7/21/21	<span style="color:red">6</span> Added Removal of Existing Delineators
7/14/21	<span style="color:red">4</span> Added Clear & Grub Limits
DATE	REVISION
STATE OF HAWAII DEPARTMENT OF TRANSPORTATION HIGHWAYS DIVISION	
<b>DEMOLITION AND EROSION CONTROL</b>	
<b>INTERSTATE ROUTE H-1 RESURFACING</b>	
Miller Pedestrian Overpass to Kapiolani Interchange	
Federal-Aid Project No. NH-HI-1(279)	
Scale: 1" = 40'	
Date: August 2021	
SHEET No. EC4 OF 23 SHEETS

<b>DEMOLITION AND EROSION CONTROL</b>	
INTERSTATE ROUTE H-1 RESURFACING	
Miller Pedestrian Overpass to Kapiolani Interchange	
Federal-Aid Project No. NH-HI-1(279)	
Scale: 1" = 40'	
Date: August 2021	
SIGNATURE	04/30/22
EXPIRATION DATE OF THE LICENSE	
SHEET No. EC7 OF 23 SHEETS

DEMOLITION AND EROSION CONTROL	
<u>INTERSTATE ROUTE H-1 RESURFACING</u>	
<u>Miller Pedestrian Overpass to Kapiolani Interchange</u>	
Federal-Aid Project No. NH-HI-1(279)	Date: August 2021
Scale: 1" = 40'	
SHEET No. EC8 OF 23 SHEETS

SHEET No. M8 OF 34 SHEETS

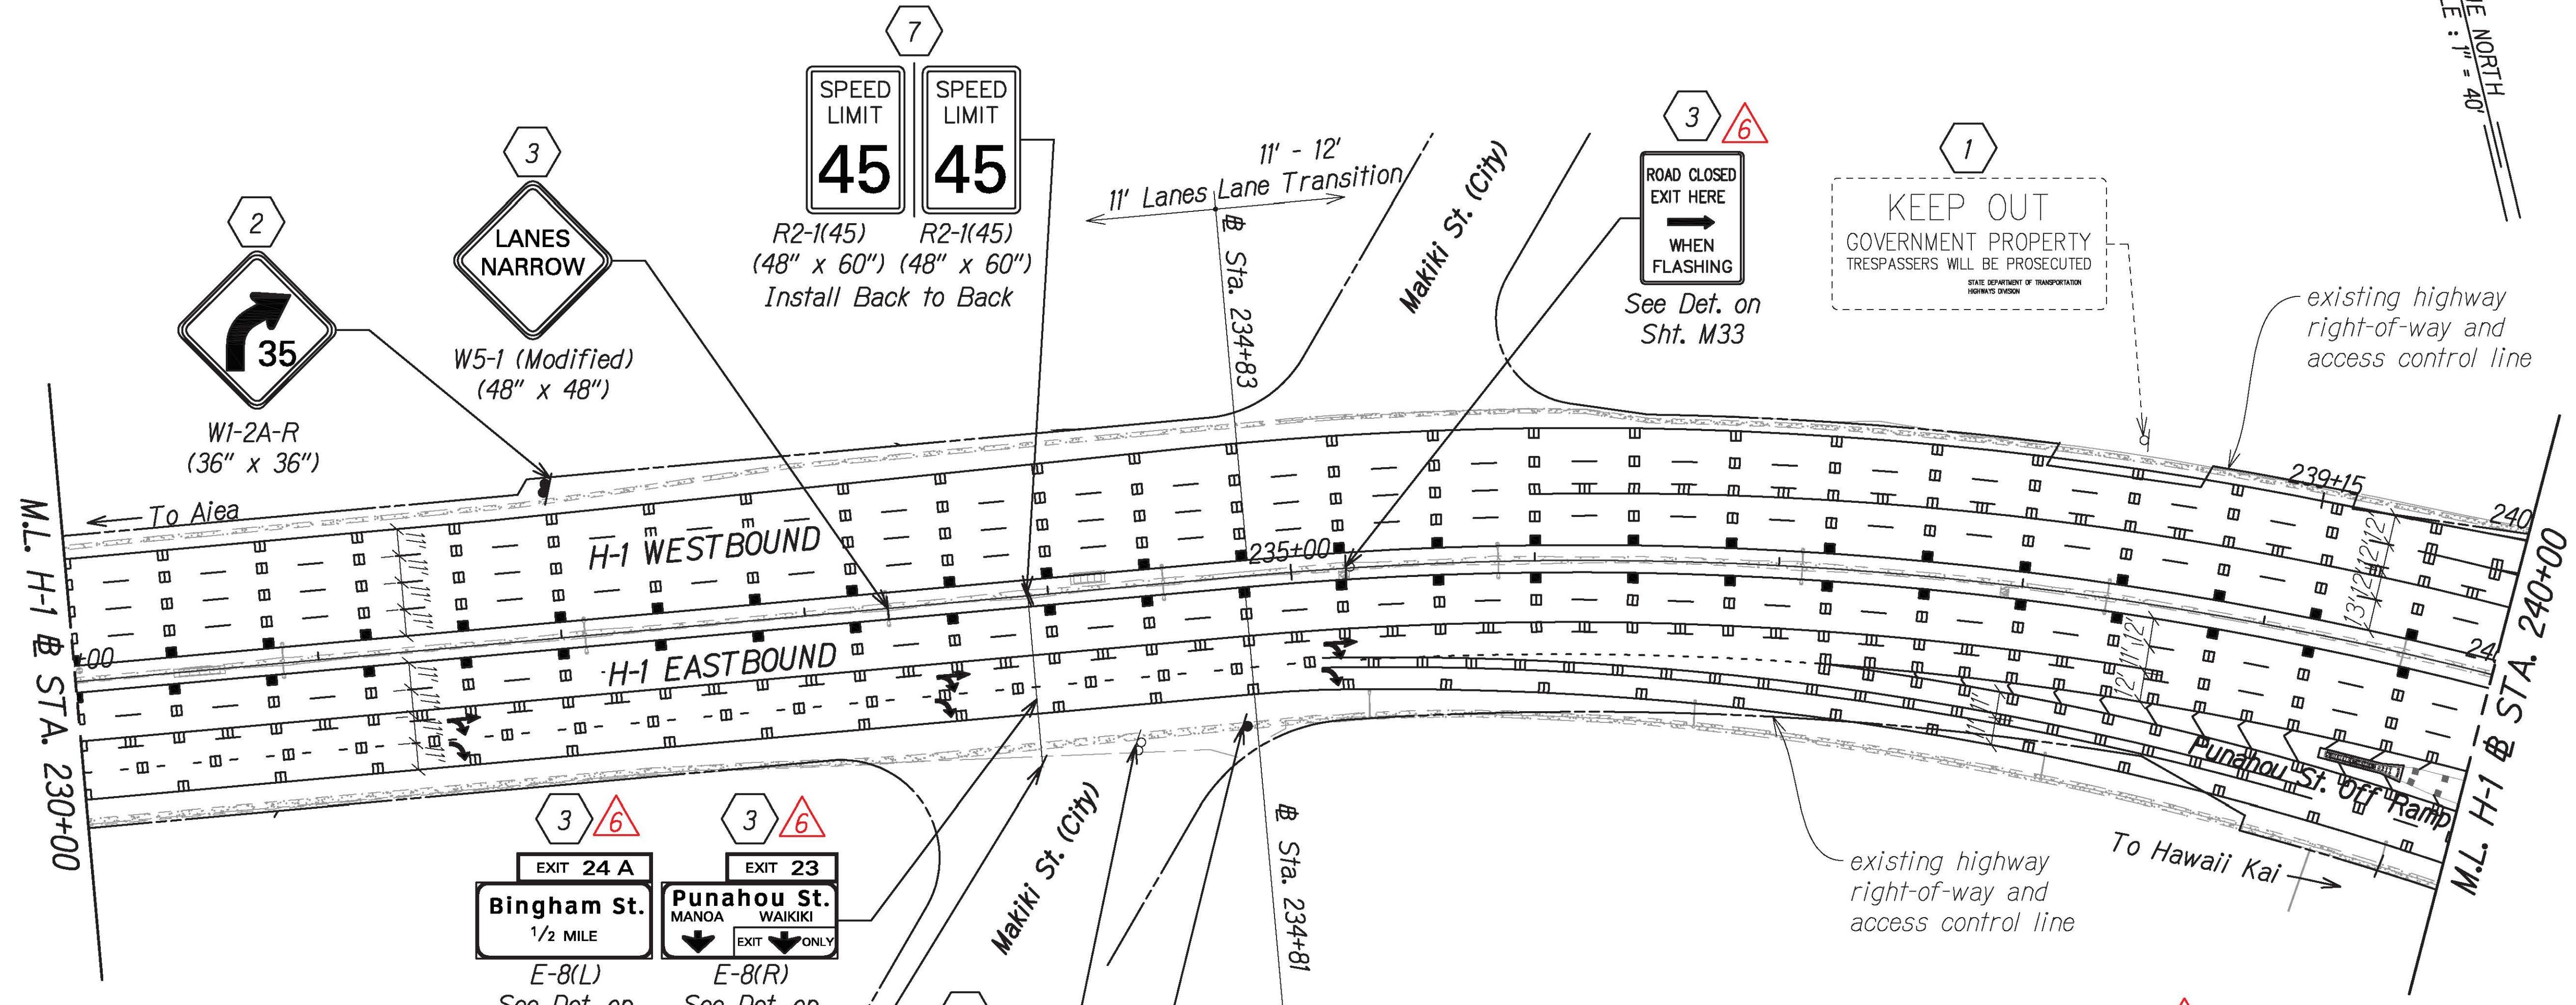
7/21/21	Removed Signing Key No. 10, Updated Sign Size and Updated Reference Note and Callout
DATE	REVISION

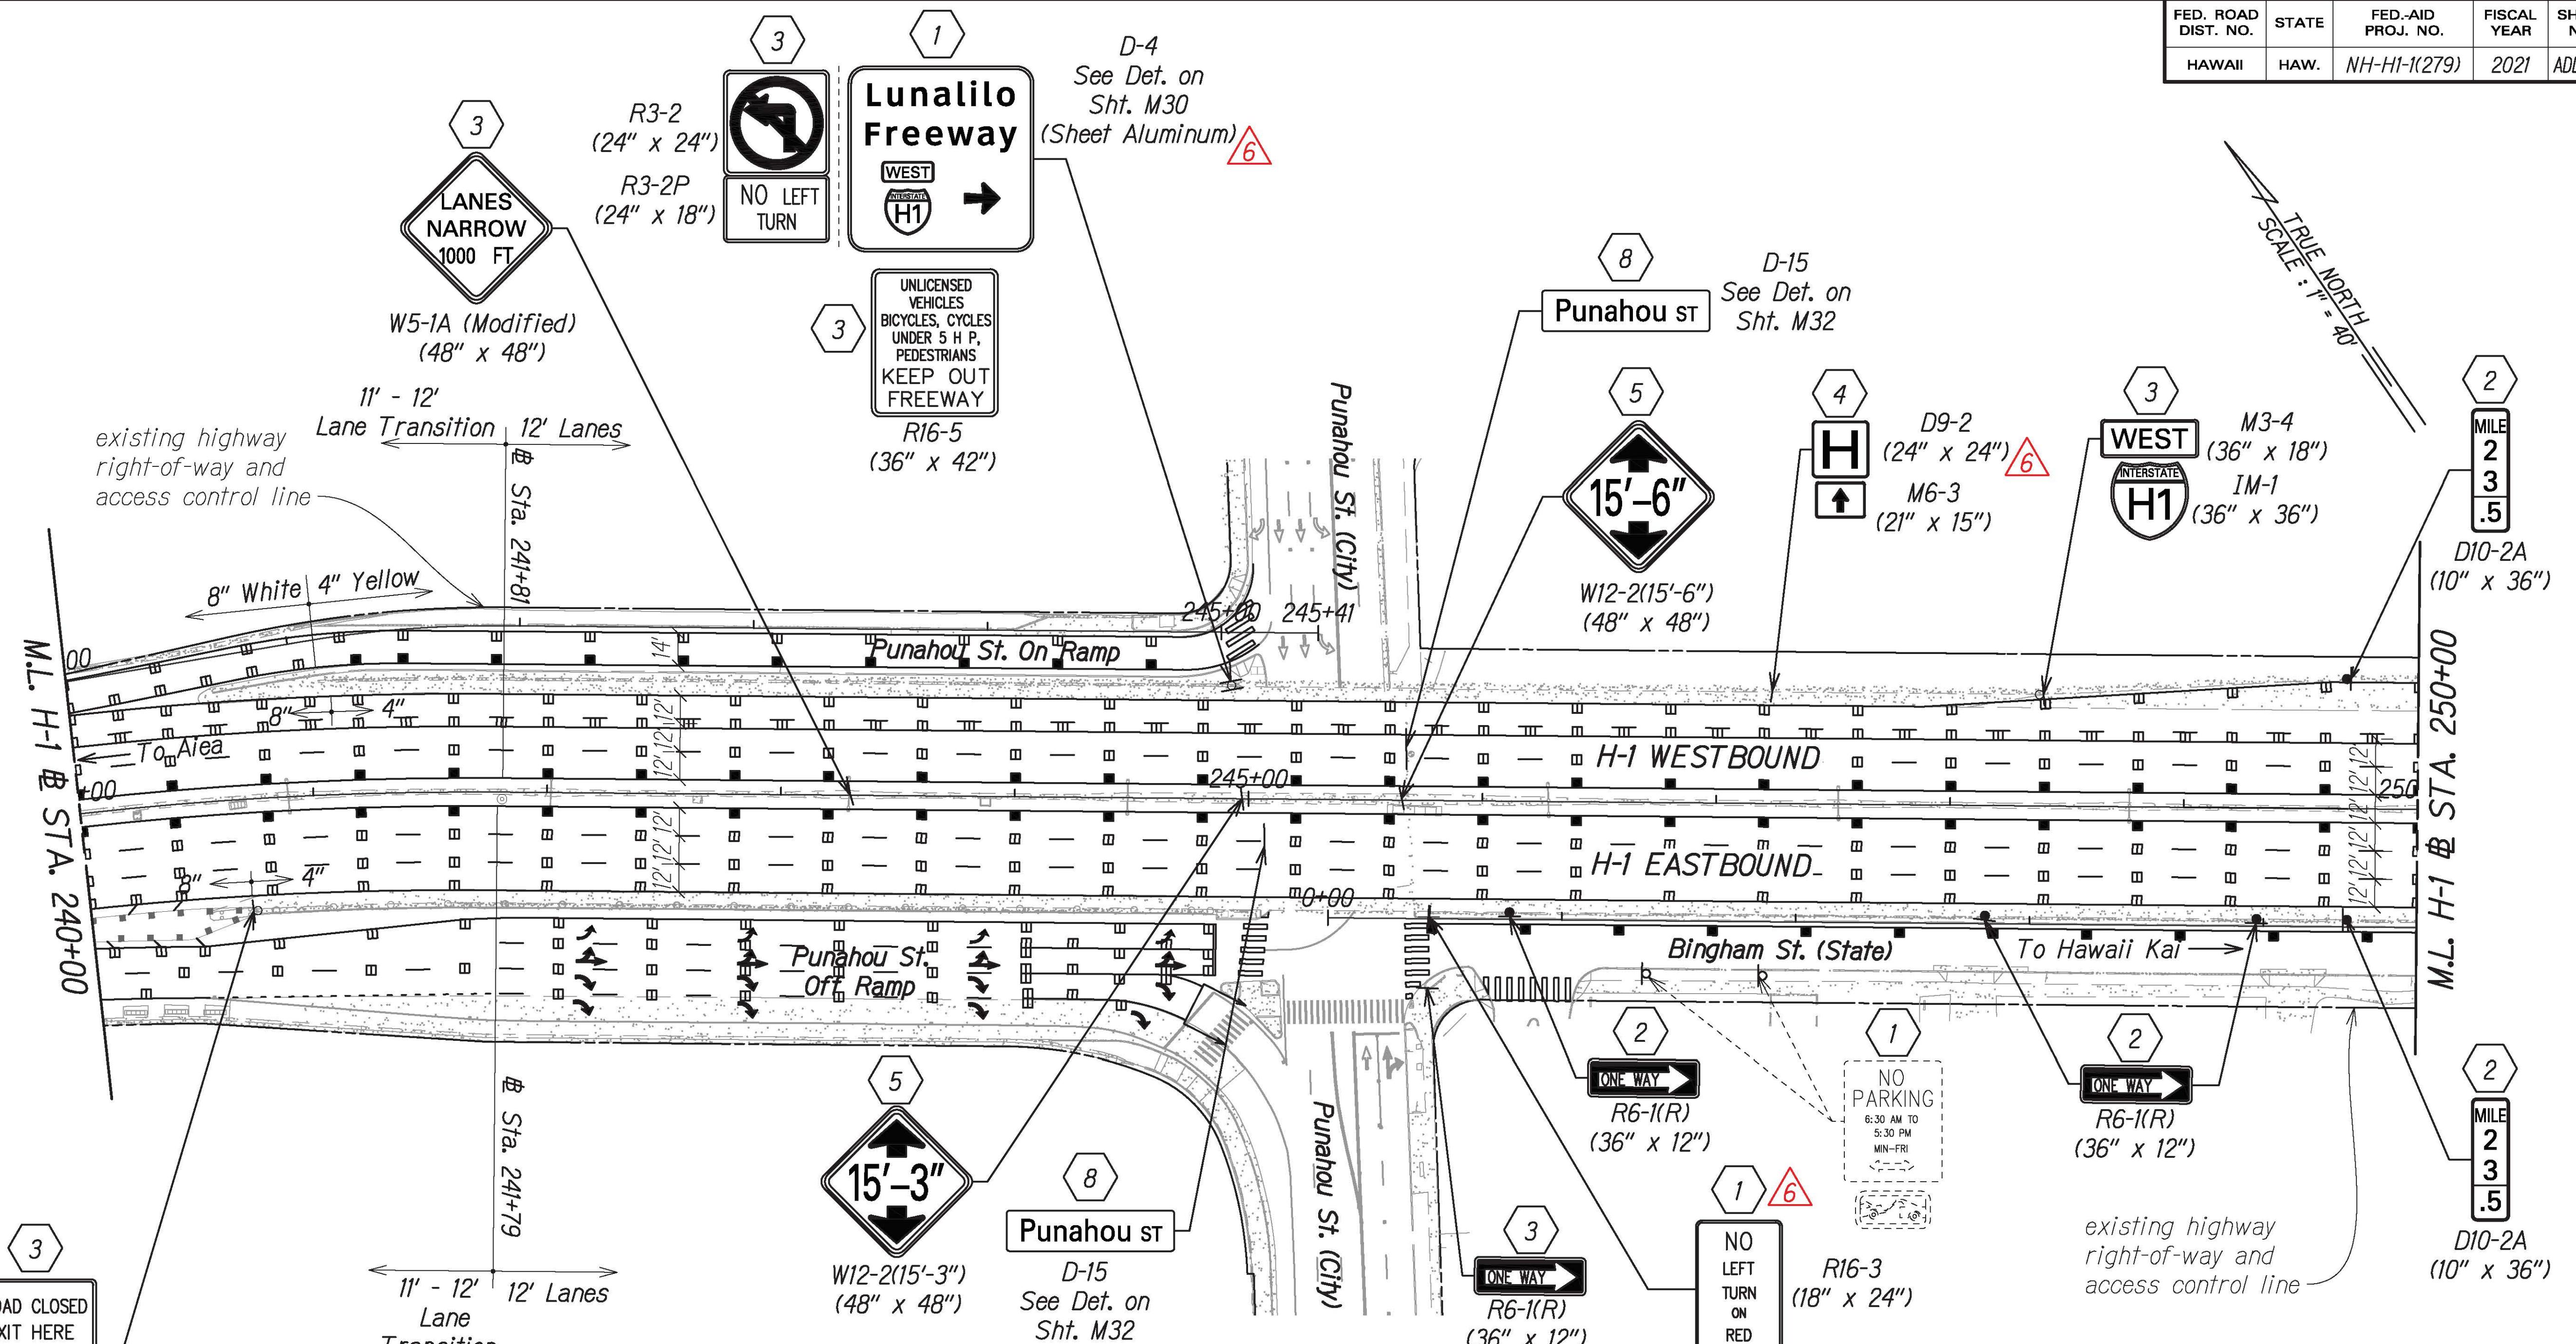
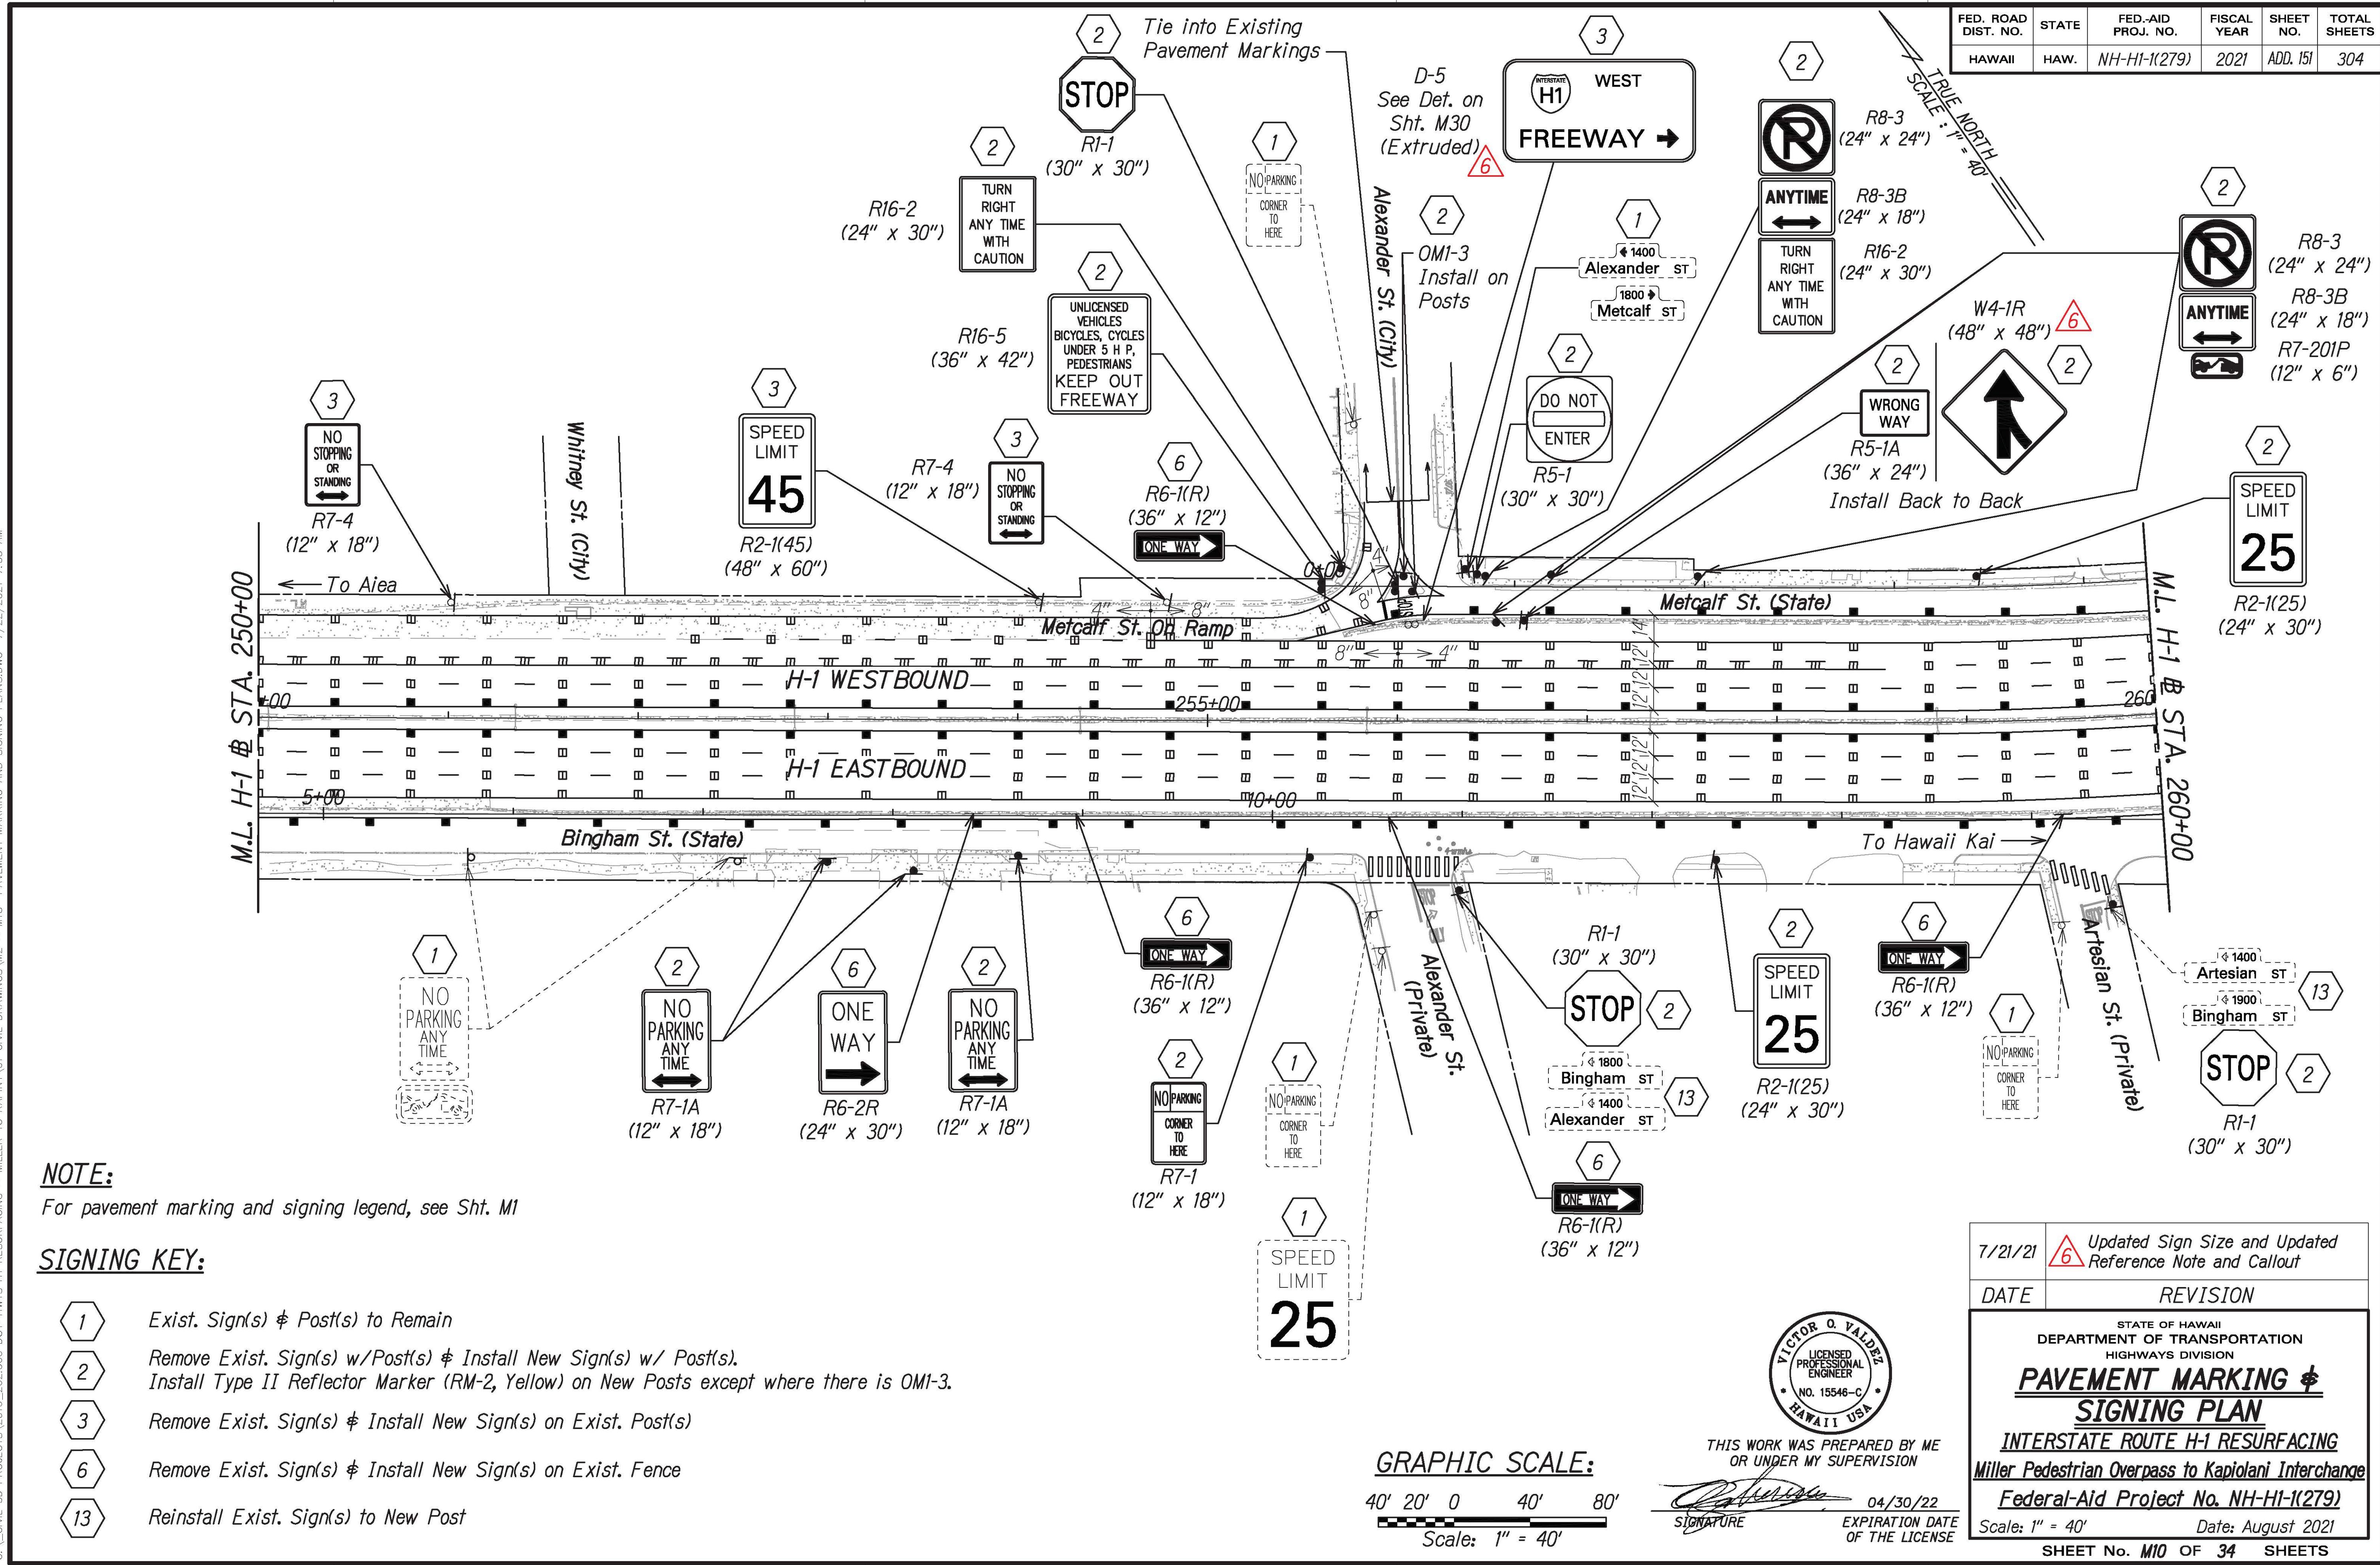
7/21/21	Updated Sign Size and Updated Reference Note and Callout
DATE	REVISION
STATE OF HAWAII DEPARTMENT OF TRANSPORTATION HIGHWAYS DIVISION	
<b>PAVEMENT MARKING &amp; SIGNING PLAN</b>	
INTERSTATE ROUTE H-1 RESURFACING	
Miller Pedestrian Overpass to Kapiolani Interchange	
Federal-Aid Project No. NH-HI-1(279)	
Scale: 1" = 40'	
Date: August 2021	
SHEET No. M9 OF 34 SHEETS
